# CONVAIR

## COMMERCIAL CHANGE PROPOSAL

MODEL: 30-5 (Convair "600")

TITLE Specification Administrative Change (Flight and Navigational Instruments - Interconnecting, Revision of)

Page 7A, Center of Gravity Limits:

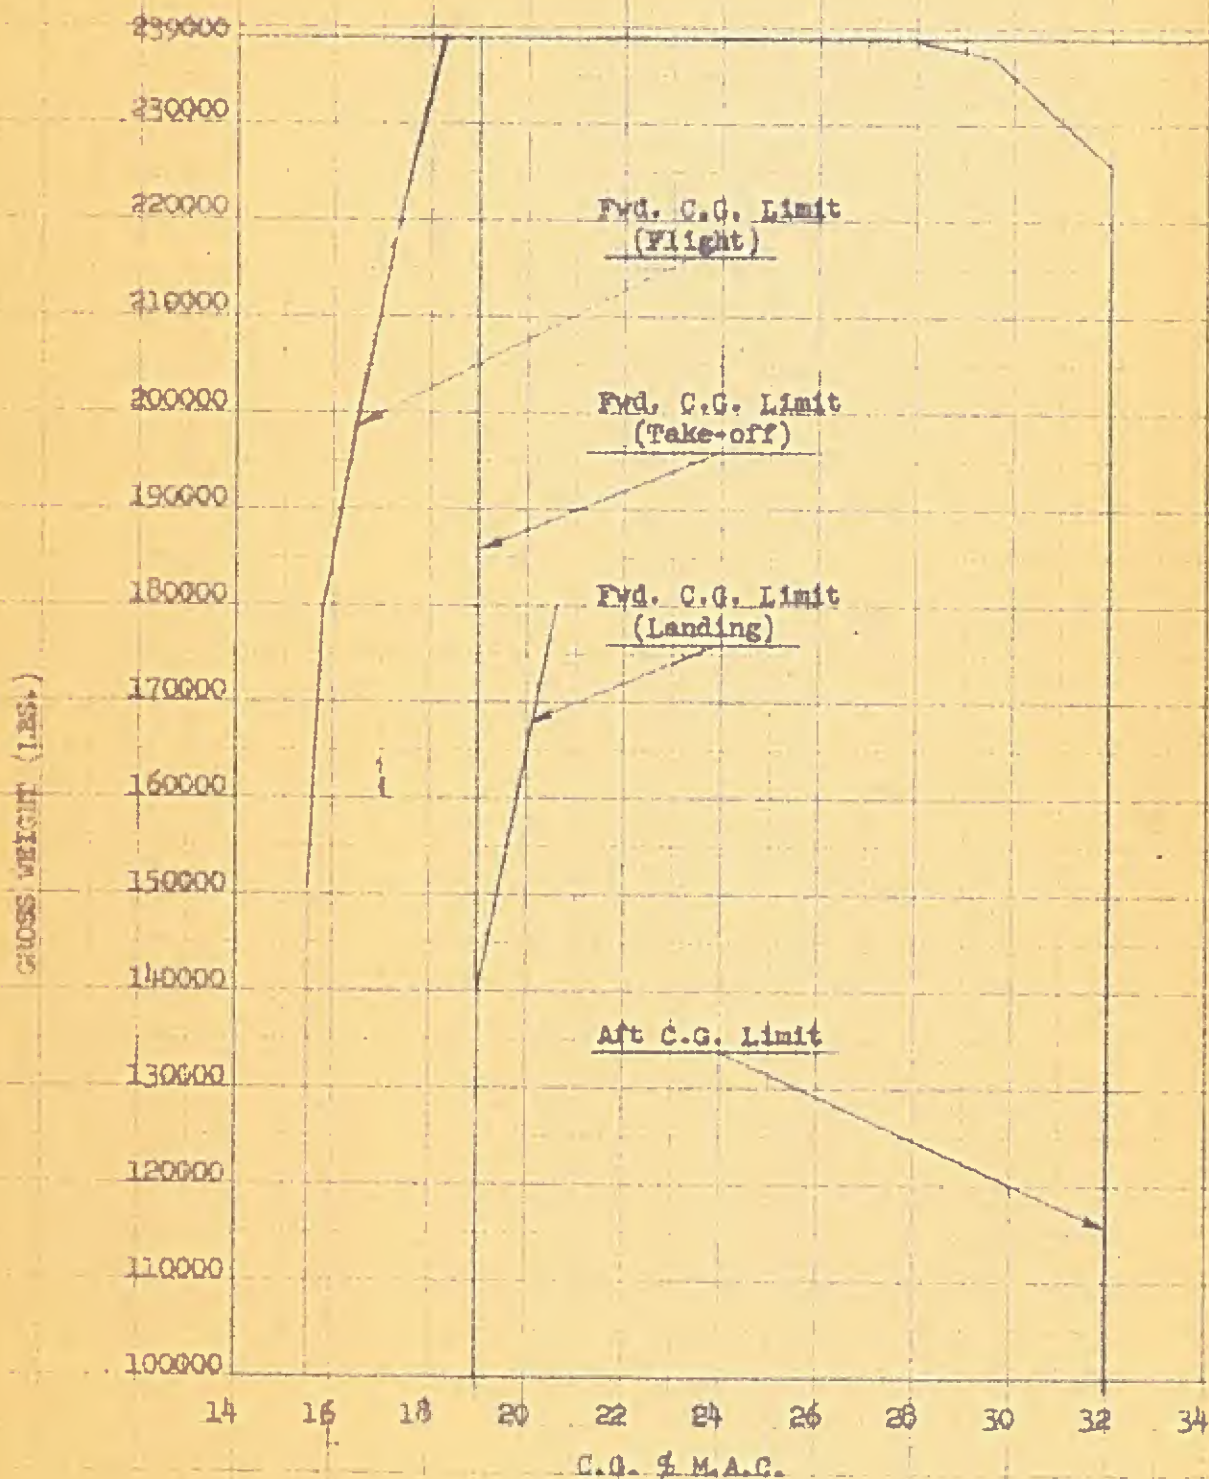
"This proposal has no effect on the specification language but  
revises the C. G. Limits Chart as shown on the attached illustration."

Enclosure: (A) One copy of Convair Sketch - CONVAIR 600 PASS. SEAT -  
ADJUSTABLE FOOD TRAY AND FOOTREST (For information only).

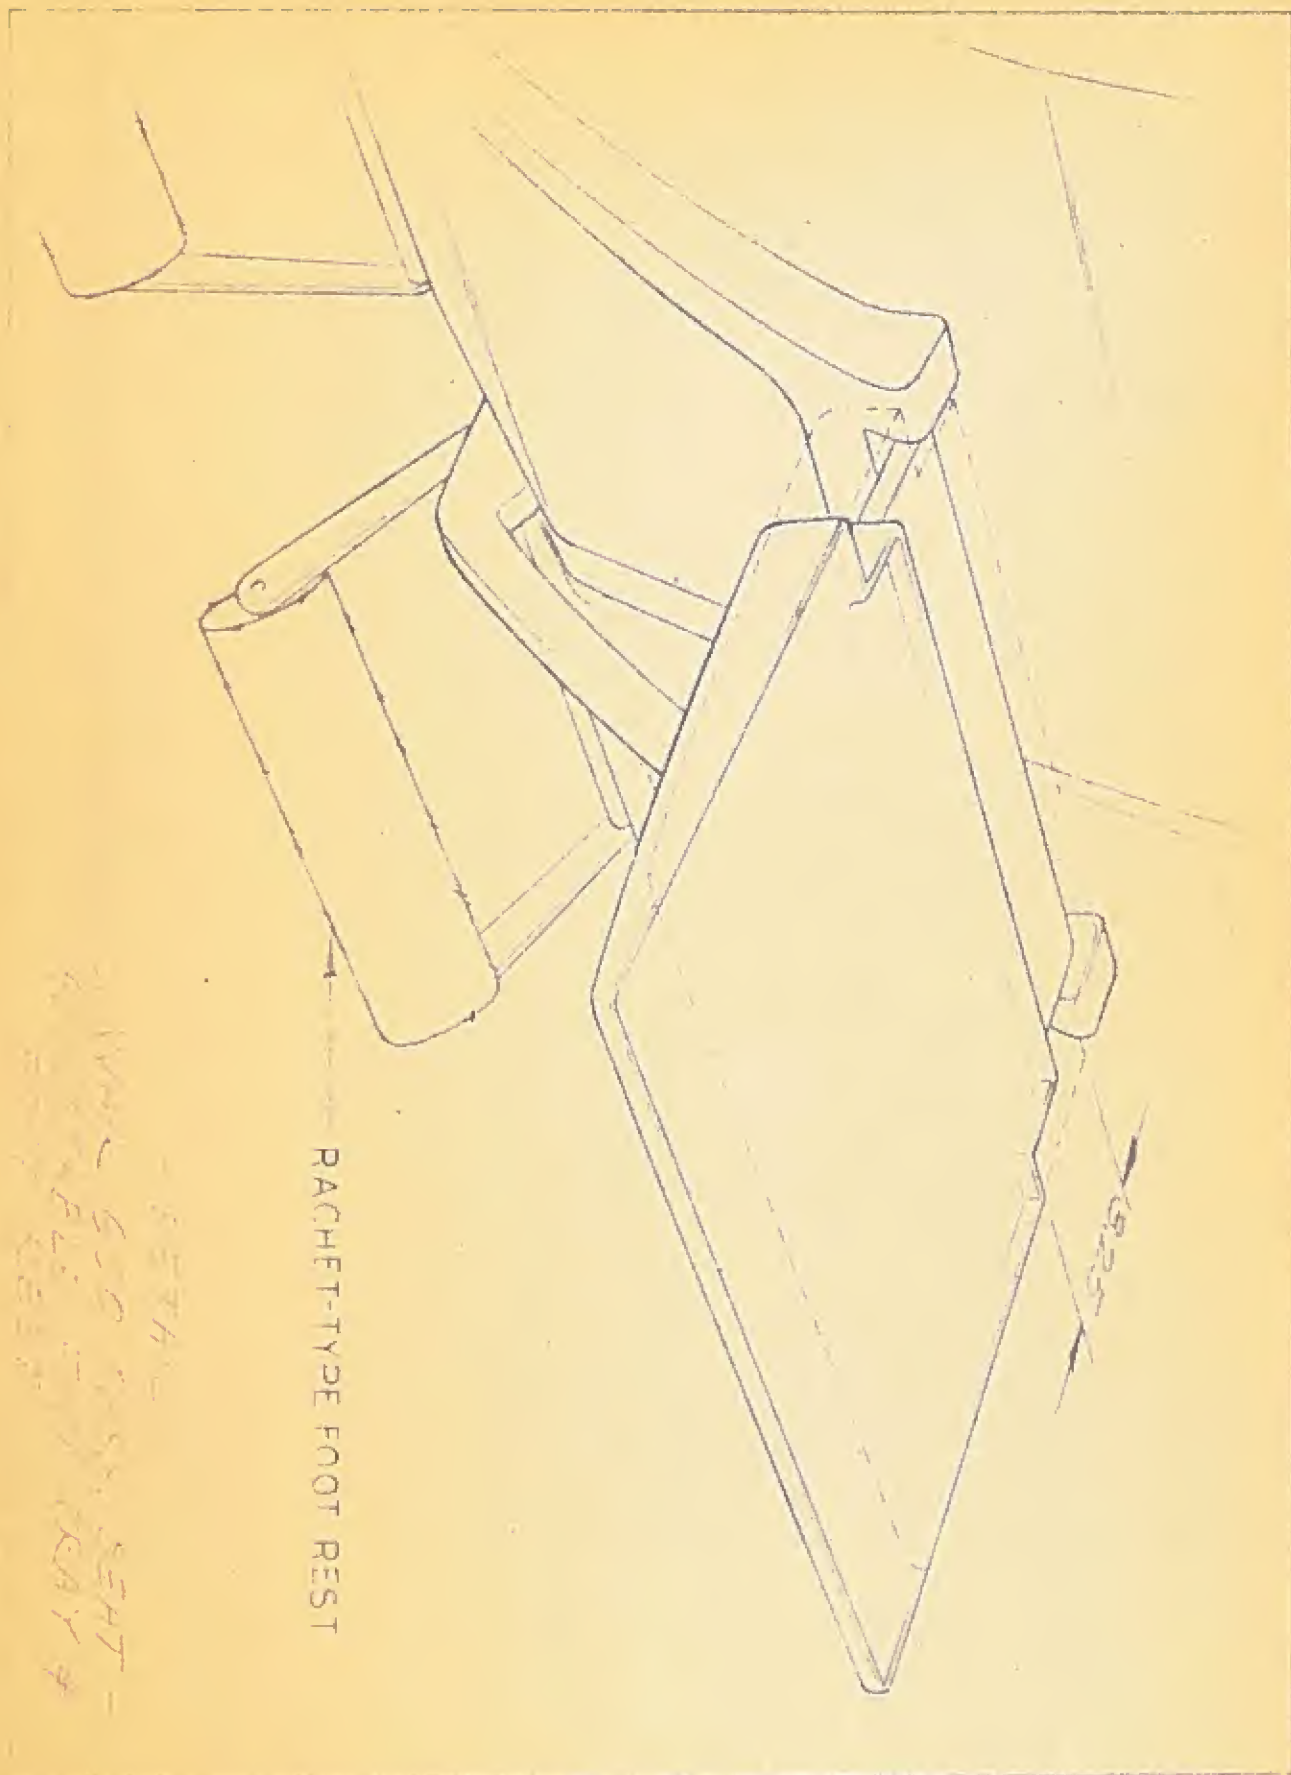
From: "Each passenger seat shall be equipped with a footrest."

To: "A standard and a wide ratchet-type footrest shall be attached to each double seat except the last seat row, the seat row forward of the movable coat dividers and the aft facing double seat."

Enclosure: (A) One copy of diagram warning horn, landing gear control and landing gear position systems (for information only)

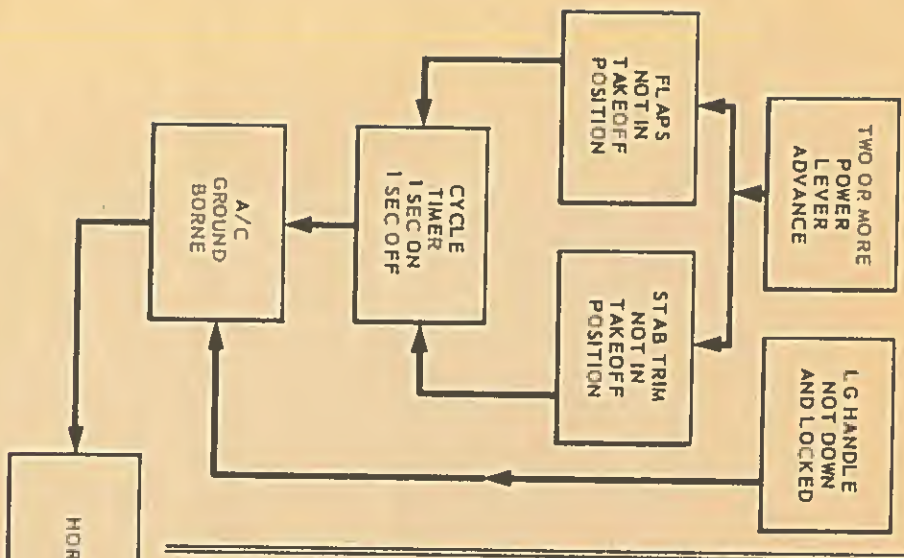
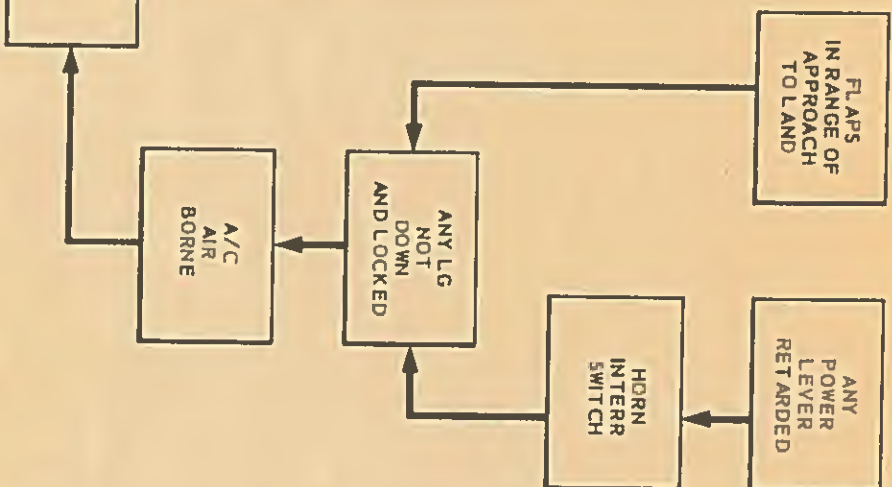
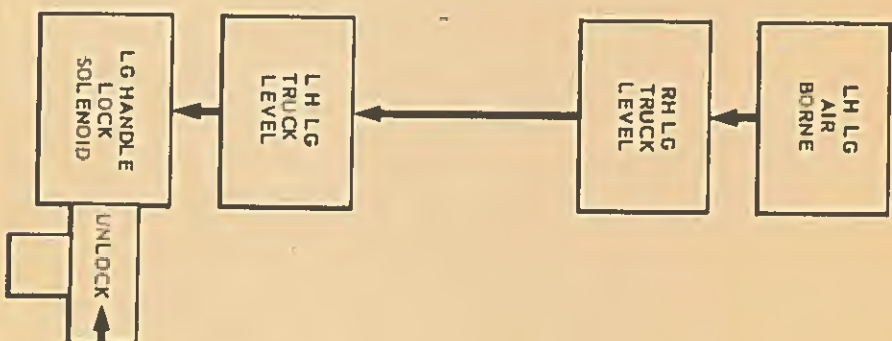
Revise the fourth sentence to read as follows:

A diagram of warning horn, landing gear control and landing gear position systems shall be provided at the next revision of the detail specification.

INFORMATION SKETCH  
CONVAIR 600 52" SEAT  
FOR A.A.L. CCP, No 31A

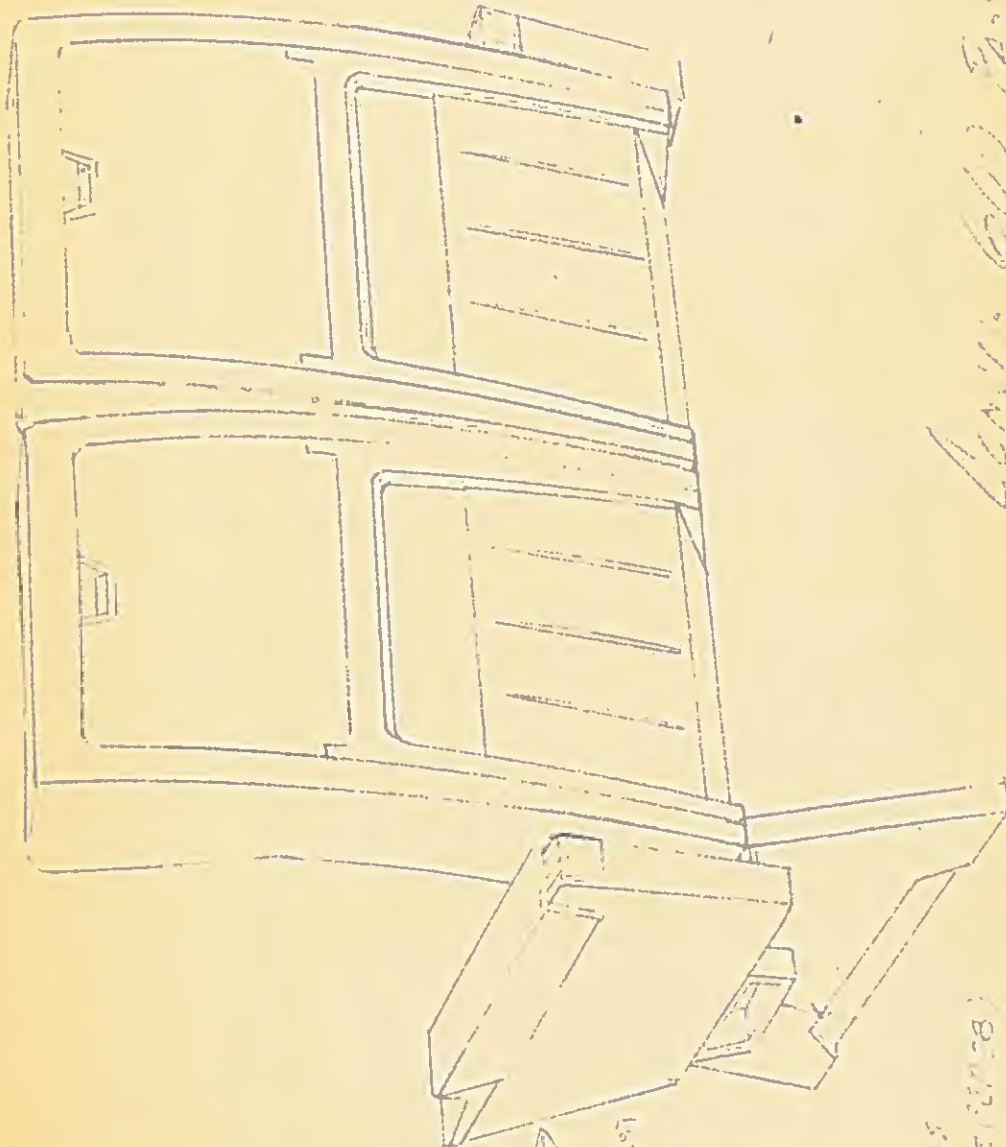
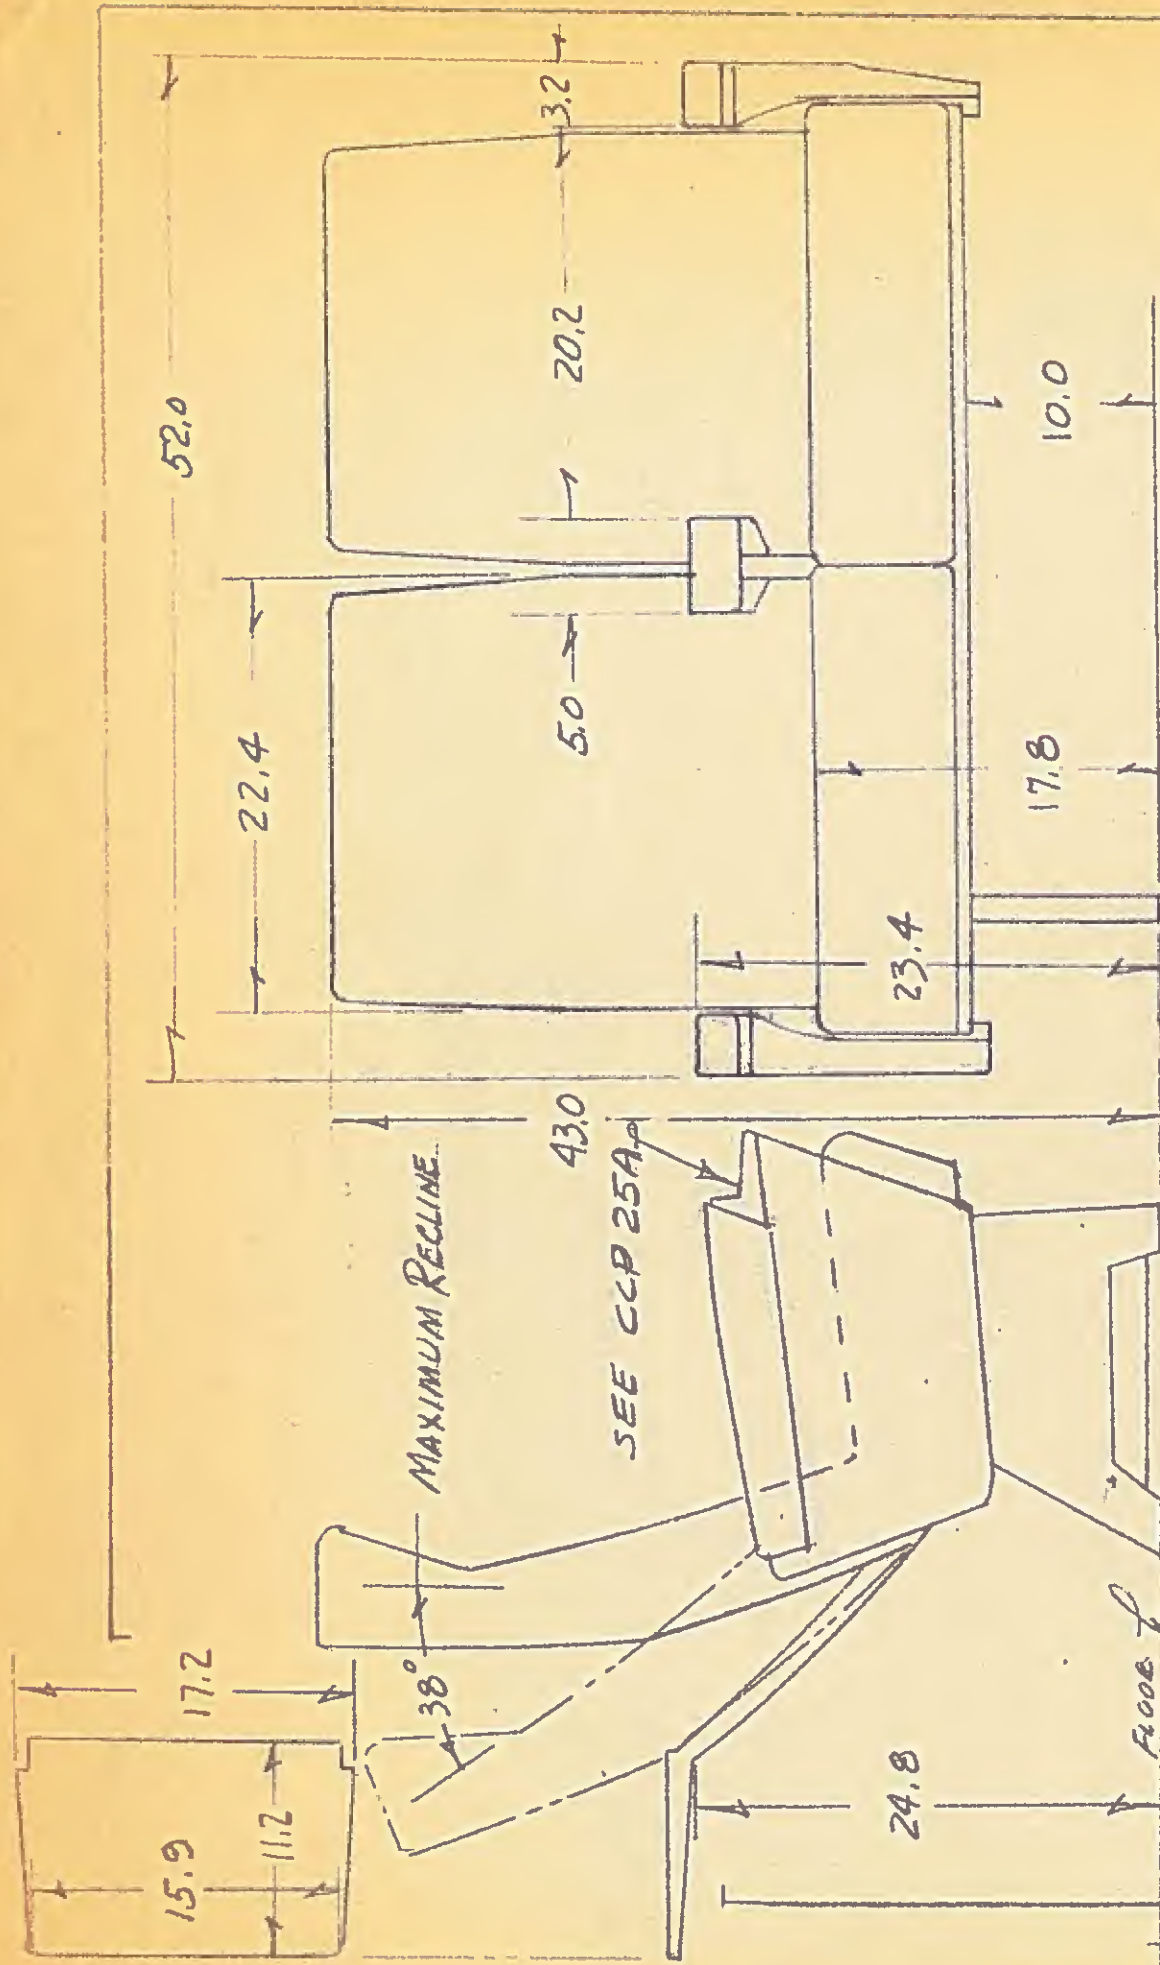
To: "82 Trays, Integral Folding (for 52-Inch Seat) 315.7"

Enclosure: (A) One copy of Convair Sketch "Convair 52 Inch Seat".  
(For information only.)

Enclosure: (A) One copy of Convair Sketch - CONVAIR 600 PASS. SEAT  
(For information only.)

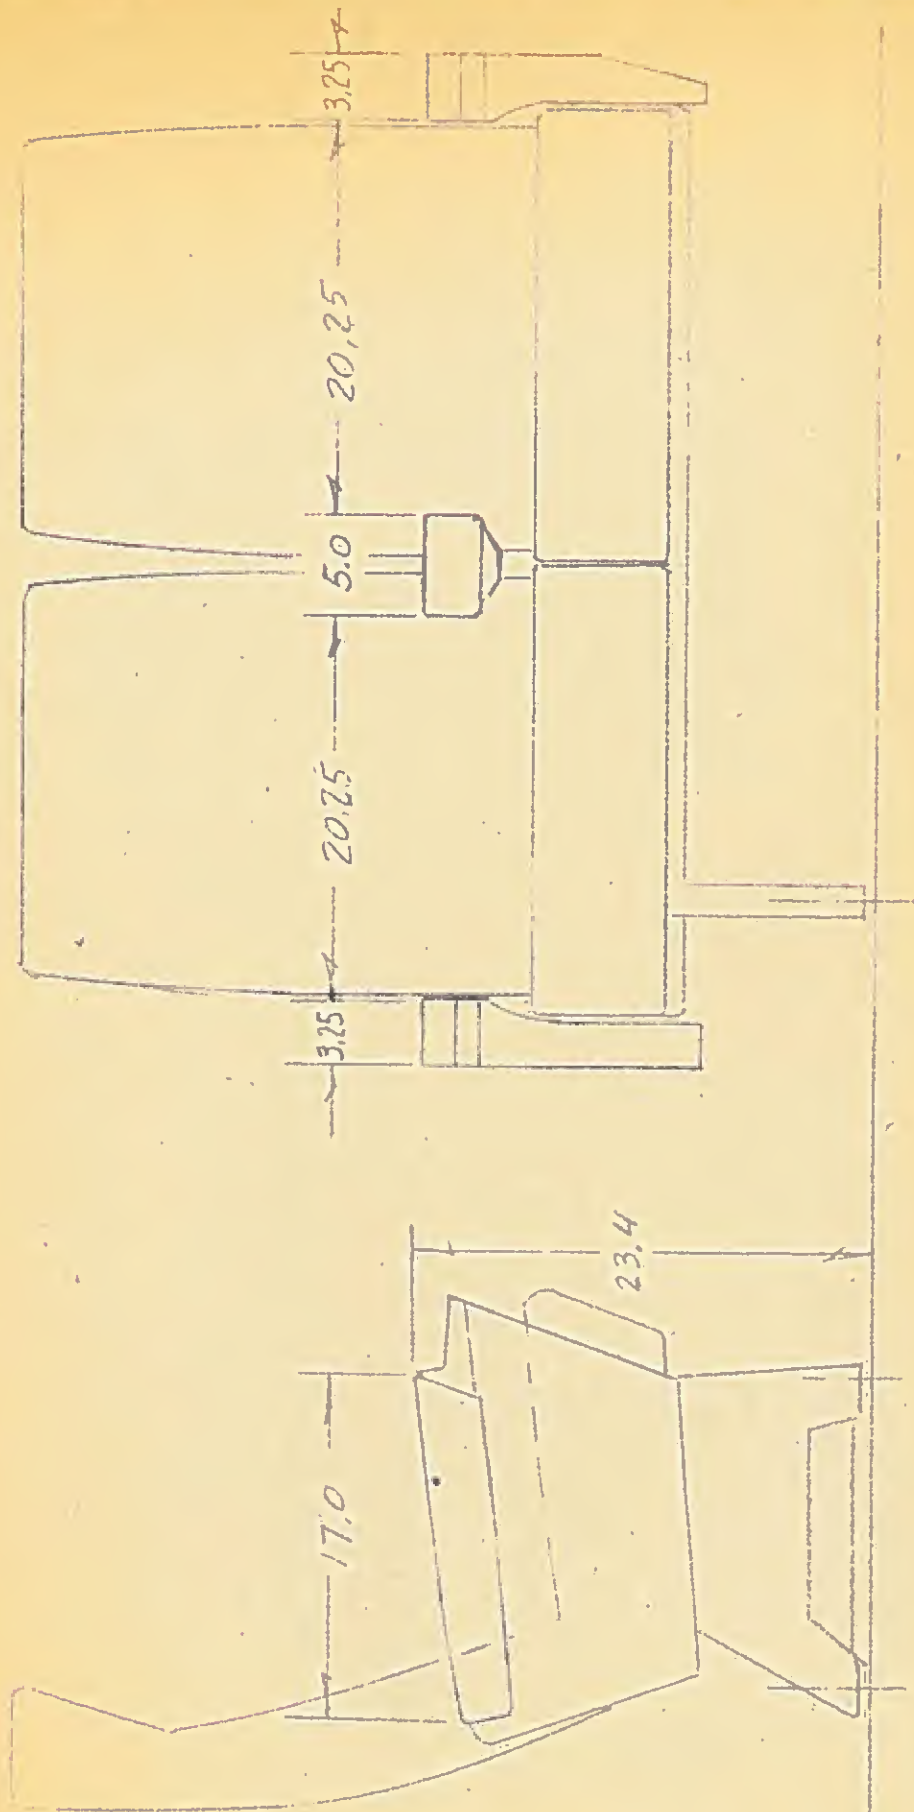
- a. Revises standard outside arm rests for minimum change to accomplish the relocated ash tray and provide wide arm bases.
- b. Redesigns plug-in receptacles.
- c. Revises recline lock handle.
- d. Increase length of arm rest.
